Proposal for Supplement 14 to the 04 series of amendments to UN Regulation No. 44 (Child restraint systems)

Submitted by the expert from the Netherlands

Figure xx

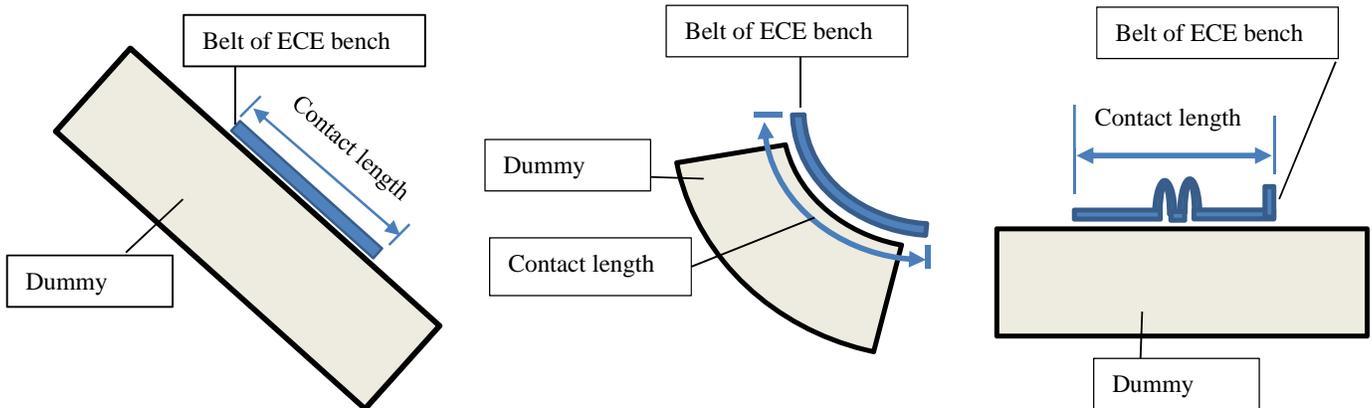
The width of the contact between the belt and the dummy shall be assessed by measuring the minimum length between the effective sides of the belt. If the belt, as seen in a cross section, takes the shape of a curve, the outside contour of the curve is measured. If the belt in cross section has folds, the contact length is defined from side to side of the belt (see figure xx below).
